Final Report - Corrections Required **Application No. DEPN-26-0068**

Description : single family residential development with optional ADU. 41 lots

Document Filename : DP Creekridge at Flying Horse Filing No 2.pdf

DRAWING DESCRIPTION
PRELIMINARY
LANDSCAPE PLAN
-OVERALL

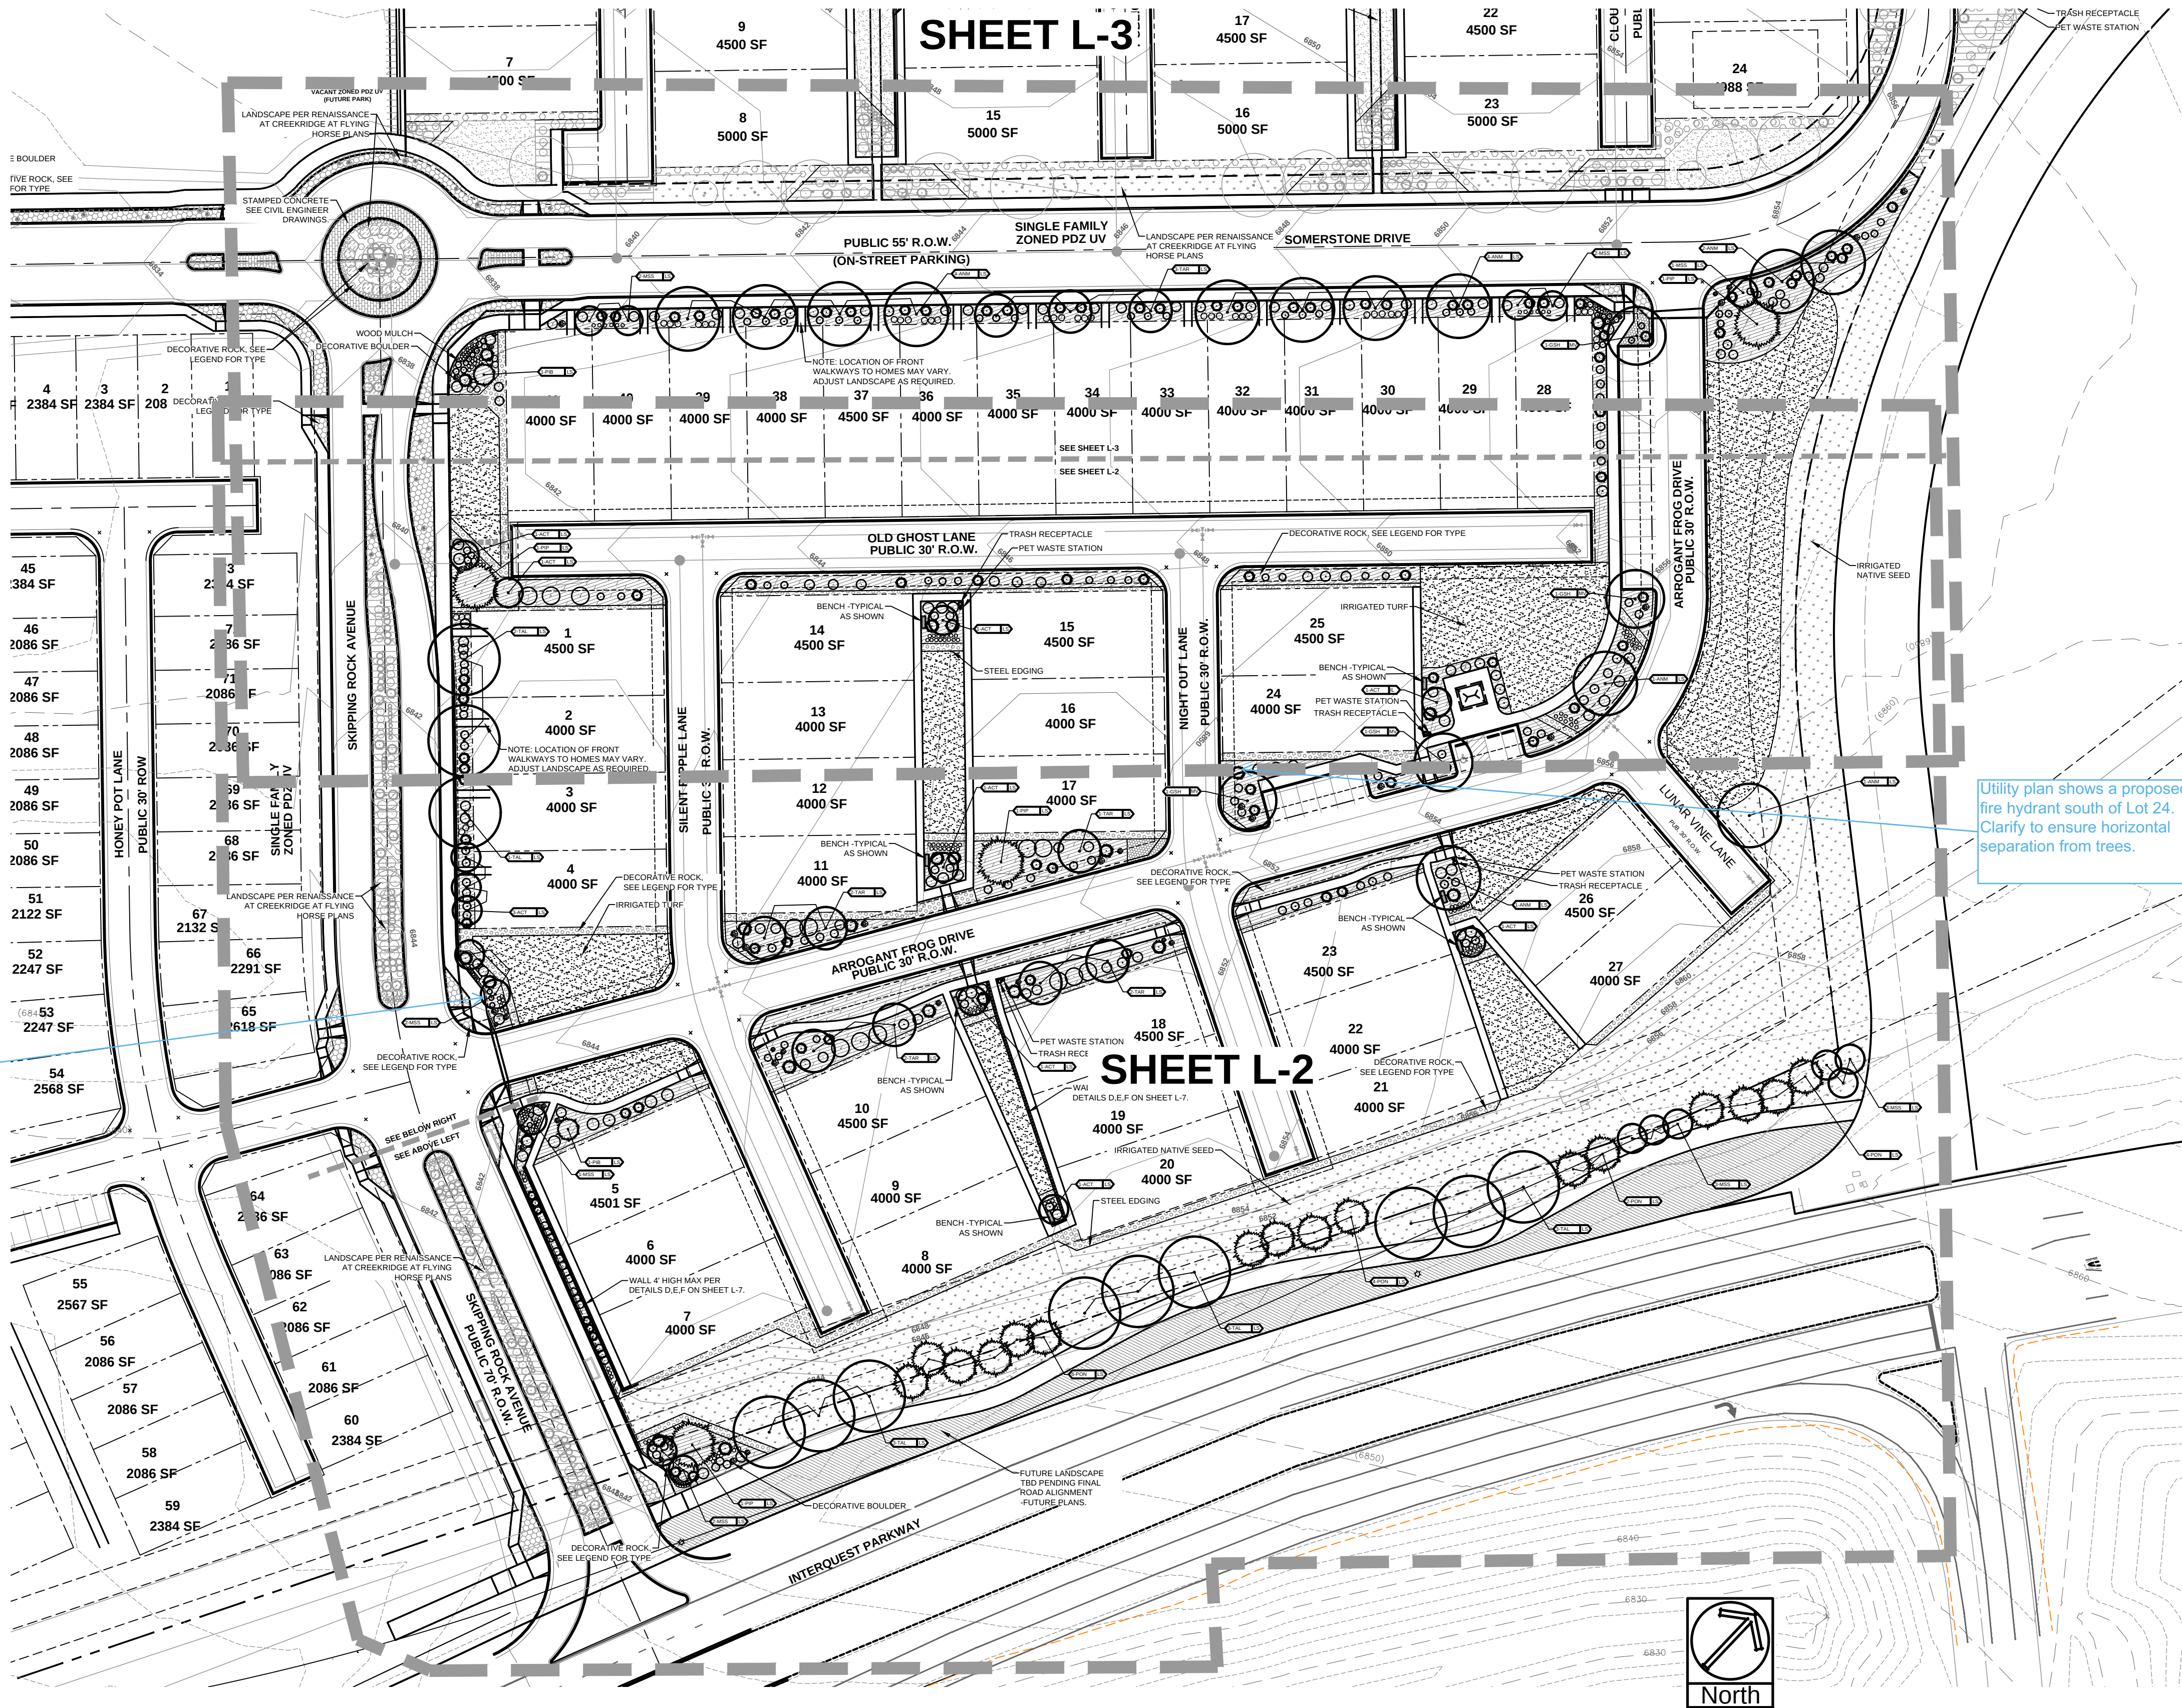
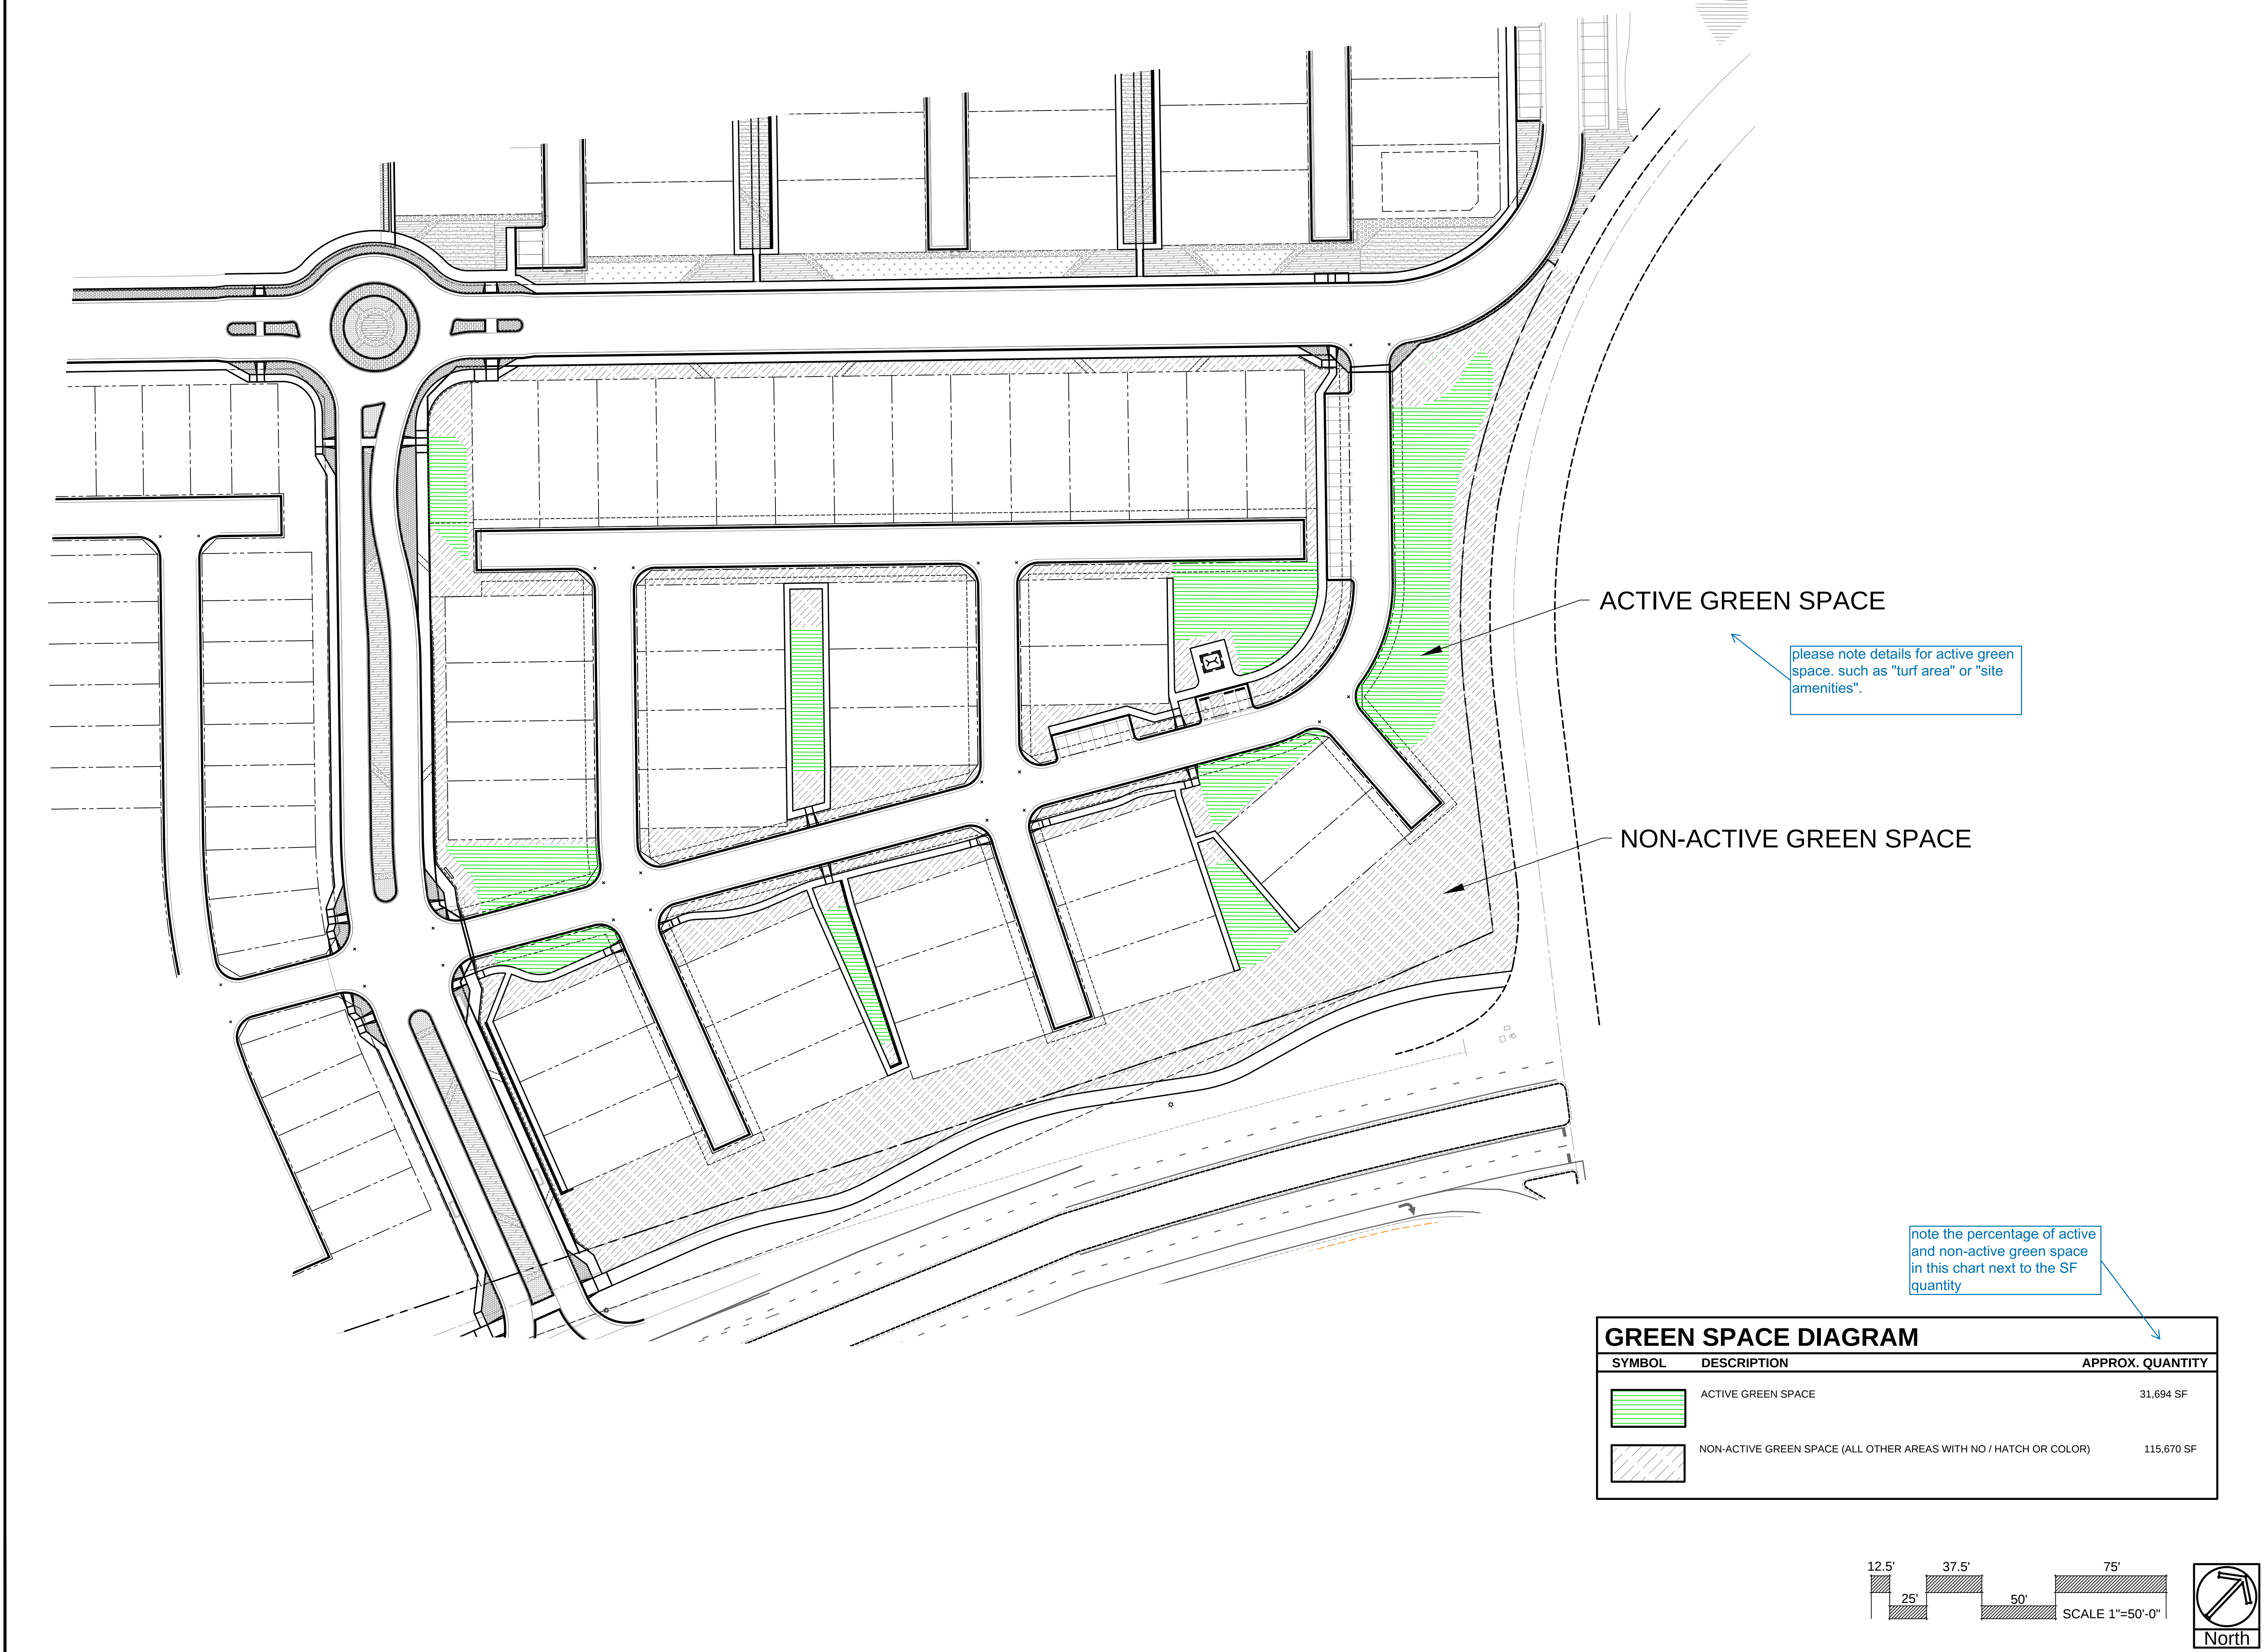
suggest removing the zone and growth rate so that other info can be made into larger text

please note details for active green space, such as "turf area" or "site amenities".

note the percentage of active and non-active green space in this chart next to the SF quantity
